THE SHOP'S AT MERIDIAN RANCH

FILING NO. 1, LOT 4
LANDSCAPE PLAN
EL PASO COUNTY, COLORADO.
FALCON, COLORADO

DRAWING NO. **2**
LANDSCAPE PLAN

FILE NUMBER: PPR18033

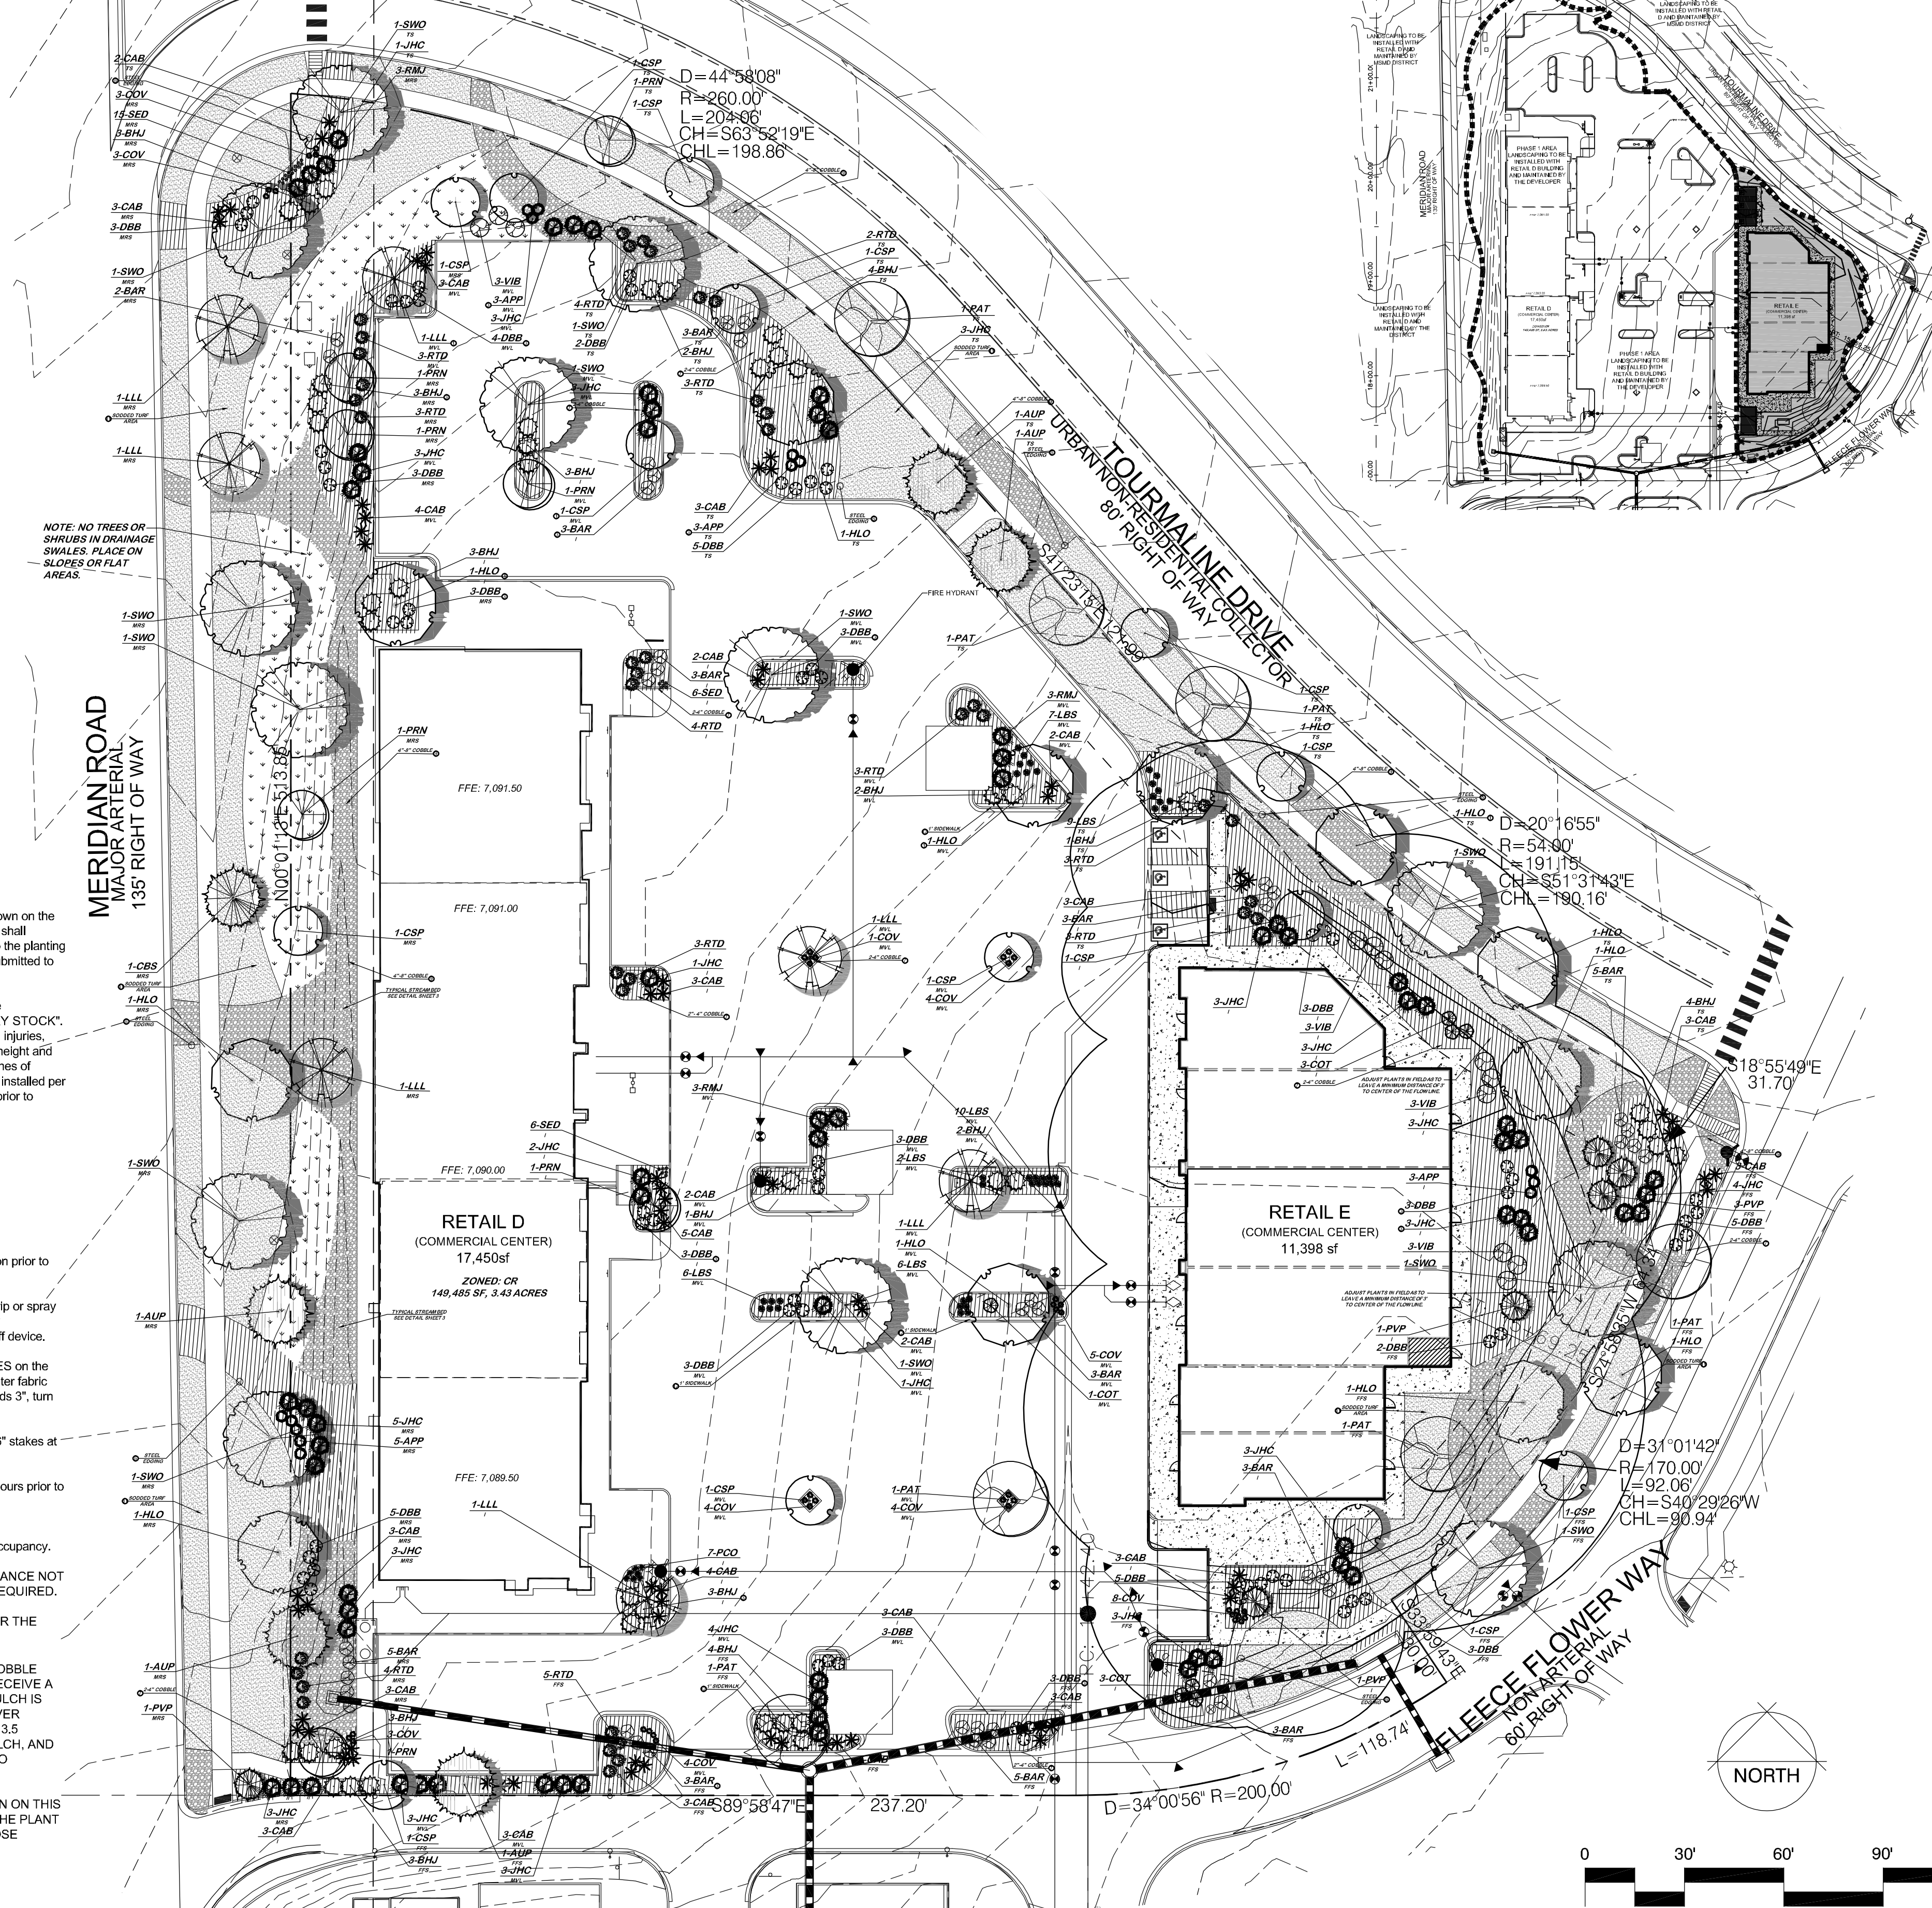
Please provide area calculation table for internal landscaping required and parking lot islands required

Provide justification for not meeting required threshold
